**CONCERNING ENVIRONMENT IMPACT ASSESSMENT OF DISMANTLING AND  
DECONTAMINATION OF EQUIPMENT FROM THE WORKING AREAS R1 AND R2 OF  
THE IGNALINA NUCLEAR POWER PLANT UNIT 2 REACTOR (PROJECT 2102)**

**Ответы на вопросы белорусских ведомств, представленных в письме «№г. 11-1-1/9-ино от 2022-01-12», относительно процедуры трансграничной оценки воздействия на окружающую среду по проекту 2102 «Демонтаж и дезактивация оборудования зон реакторов R1 и R2 второго энергоблока Игналинской атомной электростанции».**

**The responses to the questions of the authorities of the Republic of Belarus provided by the letter “No. 11-1-1/9-ino of 2022-01-12” regarding the transboundary environmental impact assessment procedure for Project 2102 “Dismantling and decontamination of equipment from Ignalina Nuclear Power Plant Unit 2 reactor R1 and R2 zones”**

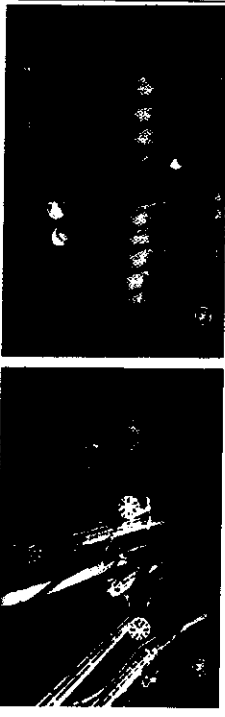
2. В конце 1993 года были выполнены работы по поднятию упавших и поврежденных ОТВС и их упорядочиванию по временной схеме хранения в бассейне 236/1 1-го блока. Работы по поднятию упавших ОТВС выполнялись в соответствии с Техническим Решением №ТР-4888, согласованным с регулятором (VATESI). Проведенный осмотр поднятых ТВС показал, что они являются облученными ТВС (ОТВС) – Акт №1-13/142. Обеспечение ядерной

Анализ безопасности хранения поврежденных ОТВС (как на фото, см. вопрос 2) был проведен и согласован с регулятором (VATESI).

Такие ОТВС и метод его хранения являлось наследием ранних лет эксплуатации ИАЭС.

В рамках проекта В1 для решения этой проблемы наследия, была разработана, обоснована и реализована специальная система обращения с поврежденными ОТВС.

В настоящее время все негерметичное, тяжело повреждённое и экспериментальное ОЯТ, включая показанные на фото ниже ОТВС, безопасно загружено в контейнеры.
